CITY OF WAUKON, IOWA

REPORT OF INDEPENDENT ROADWAY INSPECTION

2013 STREET IMPROVEMENT PROJECT

INDEPENDENT ROADWAY INSPECTION OF THE 2013 STREET IMPROVEMENT PROJECT – WAUKON, IOWA

PHOTO #13

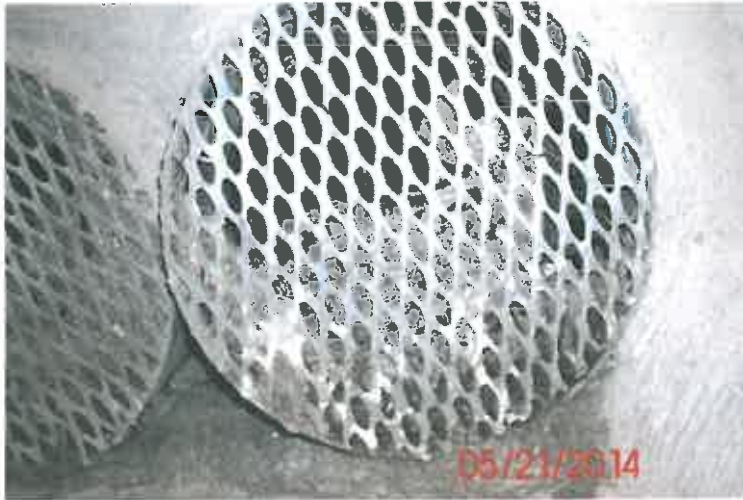
Concern #7: Debris is getting into the newly constructed subdrain system and is plugging at the subdrain outlets.

Findings: The above photo was provided to Veenstra & Kimm, Inc. by one of the property owners. As you will note, there is some debris behind the rodent guard of one of the subdrain tile.

Recommendations: It is recommended this be cleaned out and all subdrain lines connected to a surface drain be checked. If subdrains that has a surface intake connected to it and continues to be blocked with debris, it is recommended that the rodent guard be removed.

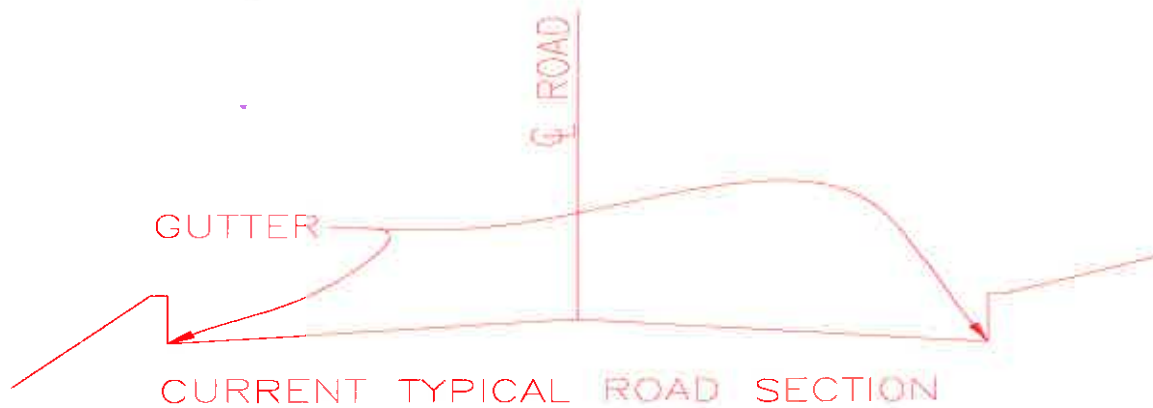
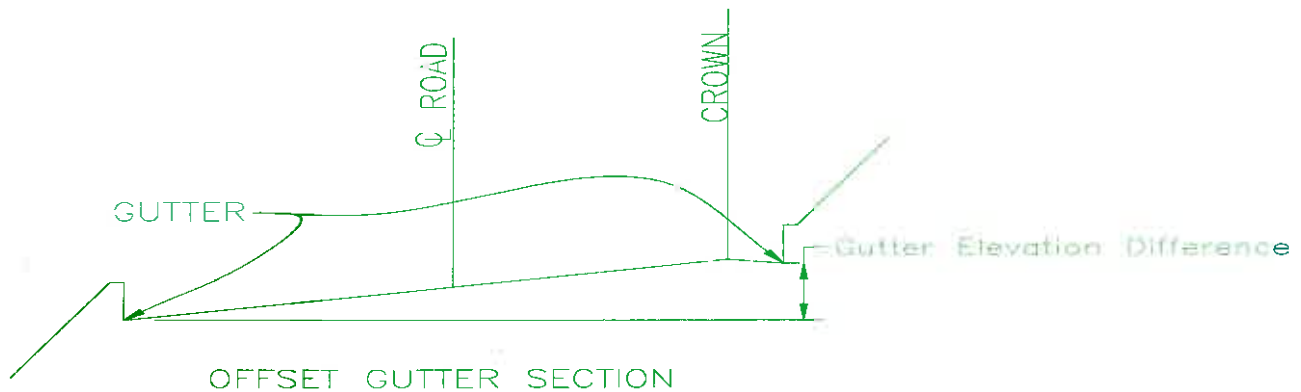
One alternate design concept Veenstra & Kimm, Inc. considered was utilizing the actual designed roadway cross-section as-is, but simply lowering the street where necessary so all of the road ROW would drain to the street. This is your typical and most desirable design concept, when/where possible. Lowering the street is an alternate design that several citizens and council members believe could have and should have been used to avoid the drainage concerns. See the "ALTERNATE TYPICAL ROAD SECTION" below.

This project as designed and as constructed has the following as the Typical Road Section. Note the slopes behind the curb and gutter:

However, when considering the alternate design concept (i.e. lowering the street), other undesirable issues likely would have resulted. These undesirable issues consist of several driveways on the east side would have been excessively steep; additional trees would have had to be removed; cover over the existing water main may have been reduced; and in some locations retaining walls likely would need to have been constructed adjacent to the ROW line.

The second design concept Veenstra & Kimm, Inc. considered was the idea of having offset gutter lines, much as the original street had. See the "OFFSET GUTTER SECTION" below. With this concept, for most of this project the east gutter line would have been higher than the west gutter line. Typically the crown of the road would be at the centerline of the road but for this concept it would need to be shifted to the higher side of the road to allow for an adequate gutter elevation difference from one side of the road to the other so that you could avoid excessively steep cross-slopes as the existing roadway appeared to have before on the southbound lane.

Again, as with the previous alternate, when considering this alternate other undesirable issues arose. These undesirable issues consist of how the road would ride; potential for drainage to sheet across the roadway causing ice issues in the winter; the carrying capacity of the higher gutter area is greatly reduced; and transitioning issues between this section and other sections or at intersections. In addition, some cutting or lowering of the existing grade would be required on the west side in some areas, thus reducing cover over the existing water main.

Thus, it is Veenstra & Kimm, Inc.'s opinion that the design concepts used by Fehr Graham for this project appear to be adequate and were appropriate for these specific circumstances.
